# Access Compliance Report

## Public Rights-of-Way

### (Curb Ramps)

Intersection ID: 21731	Main Street: BRITTANY_CT	Cross Street: INTERNATIONAL_DR	Location: S
ADA ID: 3AC25610A5F1	Ramp Type: PerpDiag	Initial Pass/Fail: Fail	Overall Compliance: No
		Severity Score: 58.75

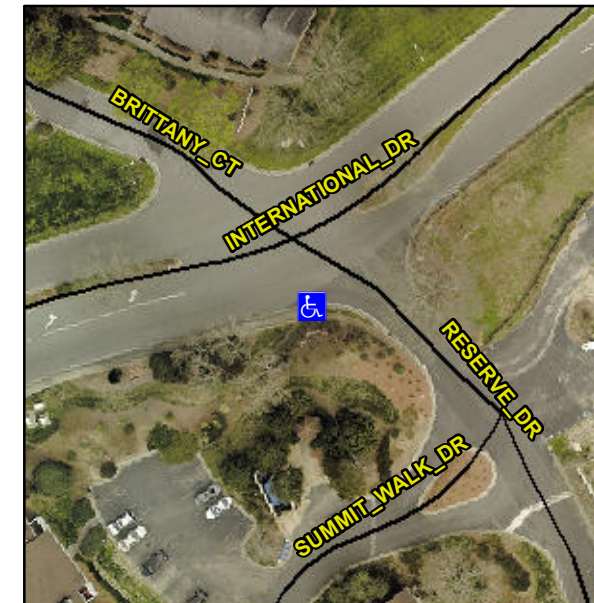
**Not Found, R304.5.1, R304.2.2, R304.5.3**

Compliance	Description	Data	Compliance	Description	Data
N/A	Ramp Length (in)	26.0	No	Ramp Slope (%)	15.5
No	Ramp Width (in)	46.0	No	Ramp XSlope (%)	14.9
N/A	Flare Type LT	N/A	N/A	Flare Type RT	N/A
N/A	Flare Slope LT (%)	N/A	N/A	Flare Slope RT (%)	N/A
N/A	Flare Traversable LT?	N/A	N/A	Flare Traversable RT?	N/A
N/A	Landing Length (in)	N/A	N/A	DWS Provided?	N/A
N/A	Landing Width (in)	N/A	N/A	DWS Contrast?	N/A
N/A	Landing Slope (%)	N/A	N/A	DWS Length (in)	N/A
N/A	Landing X Slope (%)	N/A	N/A	DWS Full Width?	N/A
N/A	Landing Curb? (Y/N)	N/A	N/A	DWS Offset (in)	N/A
N/A	Shared Landing?	N/A			
N/A	Gutter Ponding?	N/A	N/A	Gutter Slope (%)	N/A
N/A	Gutter Lip Ht (in)	N/A	N/A	Gutter X Slope (%)	N/A
N/A	Painted X Walk1?	No	N/A	Painted X Walk2?	No
	X Walk 1 Direction	To E		X Walk 2 Direction	To N
N/A	X Walk 1 Width (in)	N/A	N/A	X Walk 2 Width (in)	N/A
	X Walk 1 Slope (%)	12.8		X Walk 2 Slope (%)	5.7
	X Walk 1 X Slope (%)	4.8		X Walk 2 X Slope (%)	12.3

**Remove & Replace Curb Ramp With Two New Directional Ramps or Equivalent.**
